2CAN020801

SUBJECT: Supplemental to Request for Alternative ANO2-R&R-005
Proposed Alternative to ASME Code Requirements for Weld Overlay Repairs
Arkansas Nuclear One, Unit 2
Docket No. 50-368
License No. NPF-6

**RESPONSE TO
REQUEST FOR ADDITIONAL INFORMATION RELATED TO
REQUEST FOR ALTERNATIVE
ANO2-R&R-005**

**ENTERGY OPERATIONS, INC.
ARKANSAS NUCLEAR ONE, UNIT 2
REQUEST FOR ALTERNATIVE
ANO2-R&R-005**

FIGURE 1

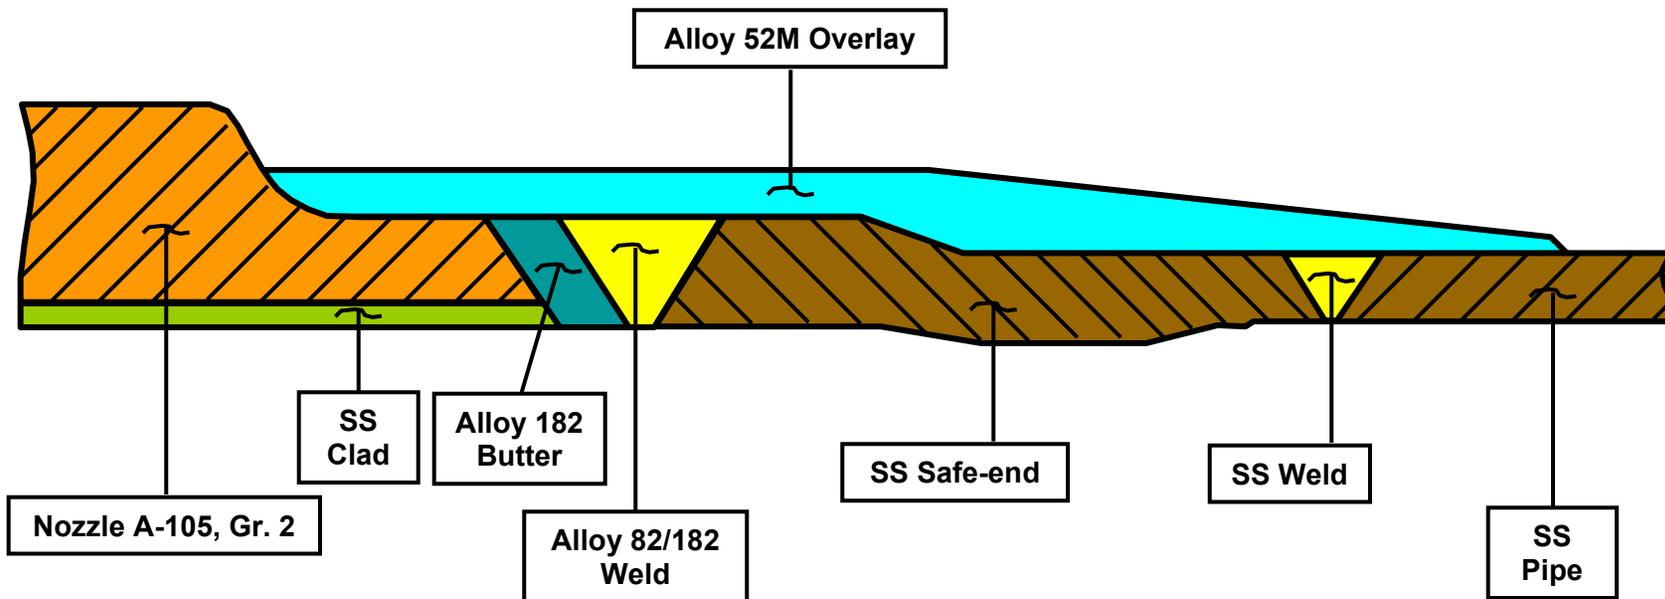
- (1) The request has been revised to reflect a design change which extends the dissimilar metal weld (DMW) weld overlays of the Hot Leg "A" Drain and Hot Leg "B" Shutdown Cooling nozzles across the adjacent stainless steel welds. These changes were made to provide for improved inspection coverage of the weld overlay at the DMW when performing preservice and inservice examinations. In the original submittal, only the weld overlay for the DMW of the Hot Leg "A" Surge nozzle was being extended to include the stainless steel weld. As a result of this change, all three (3) weld overlays addressed by this request are being extended to overlay the adjacent stainless steel welds. In support of this change, the following sections, table, and figures of the request have been revised.

- Section III, Pages 2 - 4
 - Section IV, Page 4
 - Section V.A, Page 4
 - Attachment 1, Table on "Dissimilar Metal Weld Details" and figures for "Typical Weld Overlay Detail" (Note: Three figures were consolidated into one.)

1. Nozzle material is carbon steel.
2. These ISI welds are DMWs and require preemptive structural weld overlays. Each DMW includes butter and weld.
3. These ISI welds are stainless welds joining stainless steel base materials. Therefore, they are not Inconel dissimilar metal welds.
4. To facilitate inservice inspection of ISI weld 16-003, the preemptive structural weld overlay for the DMW (16-001) of the Hot Leg "A" to Surge Line will be extended across ISI weld 16-003. See Figure 1.
5. To facilitate inservice inspection of ISI welds 35-001 and 25-001, the preemptive structural weld overlays for the DMWs will be extended across adjacent ISI welds 35-002 and 25-002, respectively. See Figure 1.

FIGURE 1

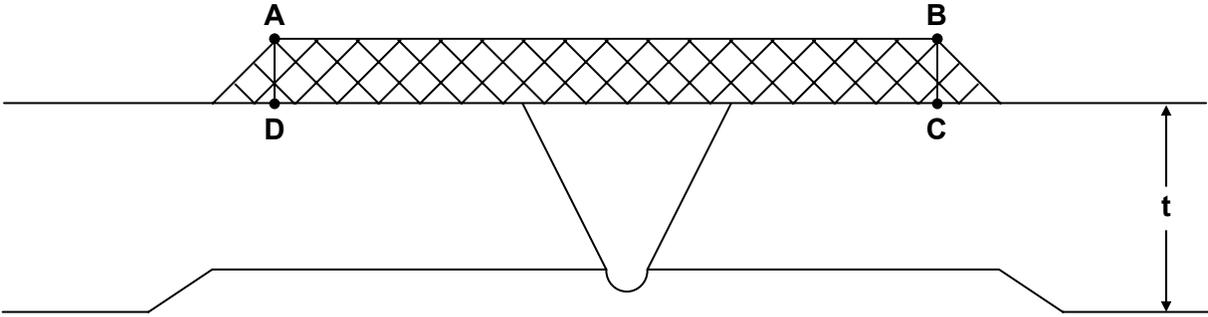
- (3) The examination volume A-B-C-D in Figure 1 (below) shall be ultrasonically examined to assure adequate fusion (i.e., adequate bond) with the base metal and to detect welding flaws, such as inter-bead lack of fusion, inclusions, or cracks. The interface C-D shown between the overlay and the weld includes the bond and the HAZ from the overlay. If ambient temperature temperbead welding is used, the ultrasonic examination shall be conducted at least 48 hours after completing the third layer of the weld overlay. Planar flaws shall meet the preservice examination standards of Table IWB-3514-2. In applying the acceptance standards, wall thickness “ t_w ” shall be the thickness of the weld overlay. Laminar flaws shall meet the following:

- (ii) The reduction in coverage of the examination volume in Figure 1 due to laminar flaws shall be less than 10%. The dimensions of the un-inspectable volume are dependent on the coverage achieved with the angle beam examination of the overlay.

FIGURE 2

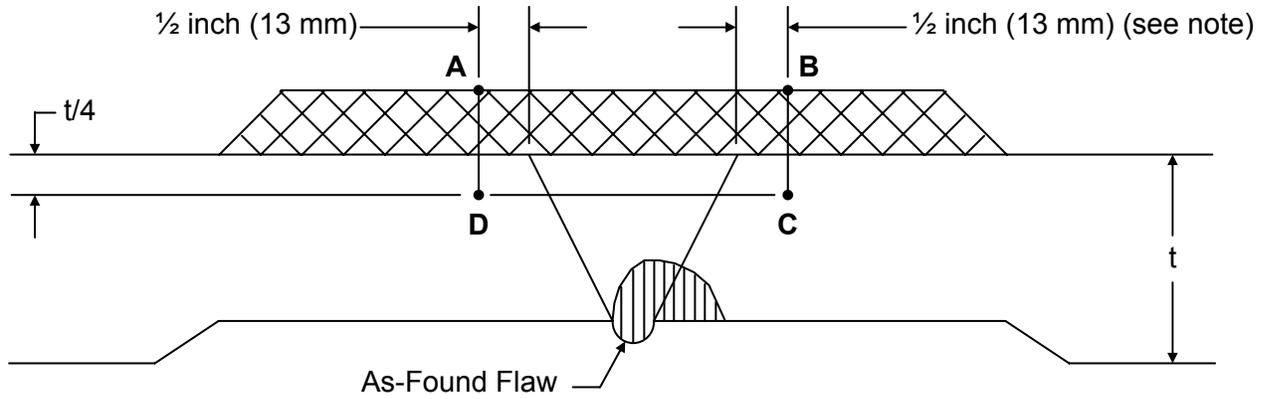
The examination volume A-B-C-D of Figure 2 for each weld overlay will be examined using ultrasonic examination procedures and personnel qualified in accordance with ASME Section XI, Appendix VIII (as implemented through PDI). However, as of the submittal date of this request, PDI-qualified procedures to examine the upper 25% of the cast austenitic stainless steel are not available. Therefore, unless PDI procedures are qualified in time to support the preservice examinations required by this attachment, Entergy will perform a "best effort" preservice examination of the Figure 2 examination volume in accordance with Appendix VIII to the extent practical and the cast stainless steel volume will be examined in accordance with Appendix III.

- (1) The weld overlay examination volume A-B-C-D in Figure 2 shall be added to the inspection plan and shall be ultrasonically examined during the first or second refueling outage following application.

- (2) The weld overlay examination volume in Figure 2 shall be ultrasonically examined to determine if any new or existing cracks have propagated into the upper 25% of the weld or base material or into the overlay. The angle beam shall be directed perpendicular and parallel to the piping axis, with scanning performed in four directions.
